AMENDMENTS TO THE DRAWINGS:

FIG.6

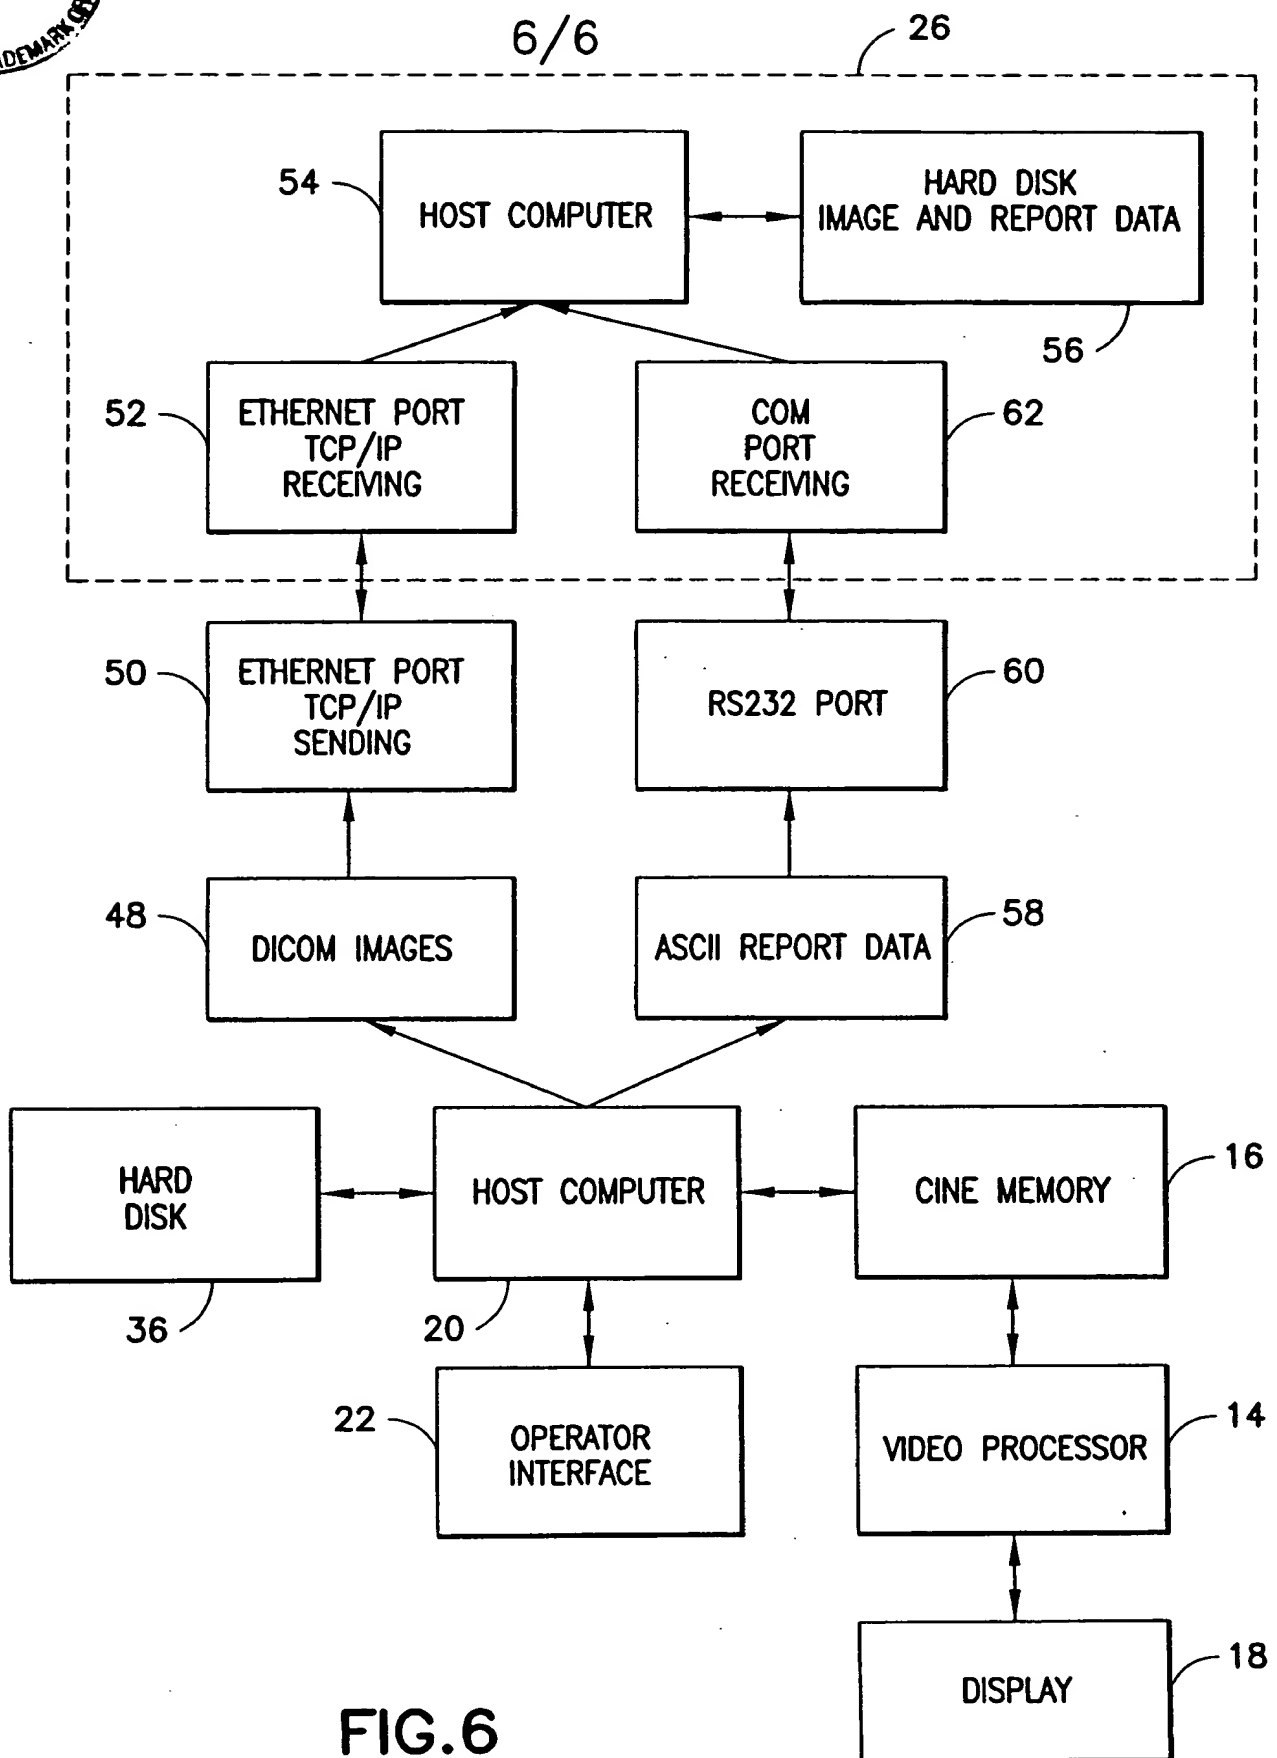
The Applicant proposes to amend the drawings as shown in the annexed copy of FIG. 6 labeled "ANNOTATED MARKED-UP DRAWING". The only change is the addition of an arrow going from block 48 to block 50, which arrow was apparently inadvertently omitted from the drawings as originally filed. Support for this change can be found on page 14 at lines 31-33, which states: "In accordance with the preferred embodiment of the invention, DICOM images 48 comprising an image header with a Study Instance UID are constructed by the host computer 20, transmitted from the Ethernet port 50, received by the Ethernet port 52, and stored on the hard disk 56 by the host computer 54." The addition of the arrow in FIG. 6 merely denotes the sending of the constructed DICOM objects 48 to the Ethernet port 50.

A new formal drawing bearing the designation "REPLACEMENT SHEET" and incorporating the aforementioned proposed amendment is also being submitted herewith.
